Project U-6243
Proposed Widening of Holly Springs Road (S.R. 1152) – Phase II
from Flint Point Lane to Sunset Lake Road (S.R. 1301) in Holly Springs, NC

Public Meeting Comment Summary
Thursday, December 3, 2020

Figure 1: Proposed School Zone Signage

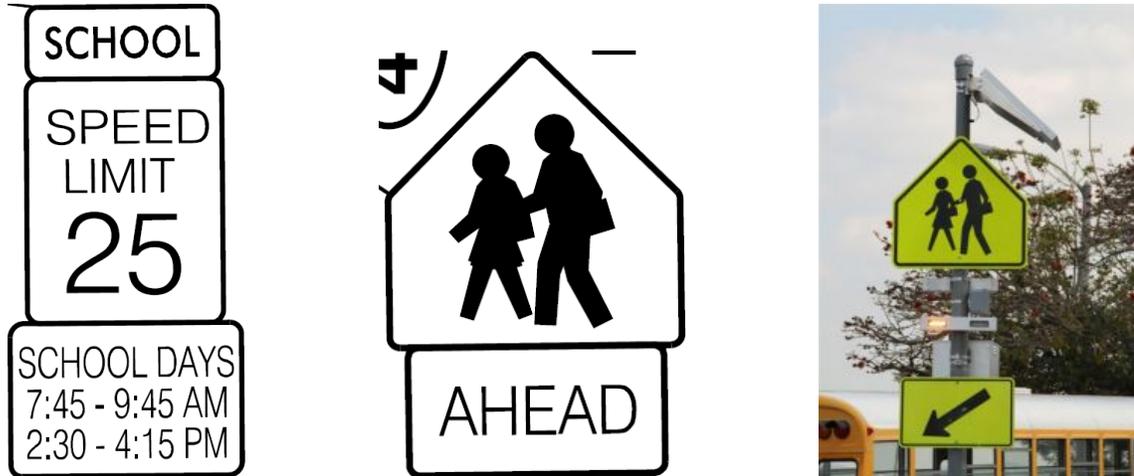
- Will the school zones associated with Holly Ridge Elementary School and Holly Ridge Middle School have flashing light signs designating the school zone like those currently at Oakview Elementary School on Holly Springs New Hill Road?

*Signage and lighting will be included near the Holly Ridge Elementary School and Holly Ridge Middle School but will be similar to current signage on Holly Springs Road. Standard school zone signs and pavement markings are proposed and pedestrian crossing signs with LED and rectangular rapid flashing beacons are proposed, similar to those shown in **Figure 1**.*

Figure 2 – Shared Lane Marking (Figure 9C-9 in the Manual on Uniform Traffic Control Design)

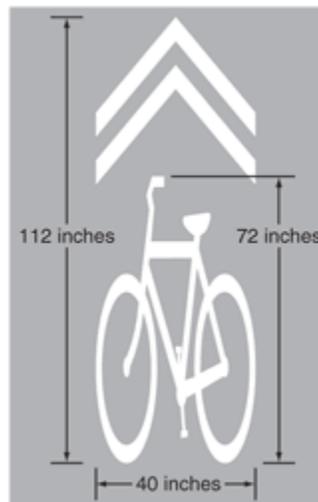
- Will bike lanes be painted on the roadway to segregate them from vehicular traffic?

*The proposed 14-foot wide outside lanes are proposed to be designated as shared-use lanes for vehicles and bicyclists using “sharrow” shared lane pavement markings as shown below in **Figure 2**. In discussions the Town Engineering staff had with the on-road bike community to discuss this project, the concern for accumulation of road debris in bike lanes and a preference for wide outside shared lanes instead was expressed.*
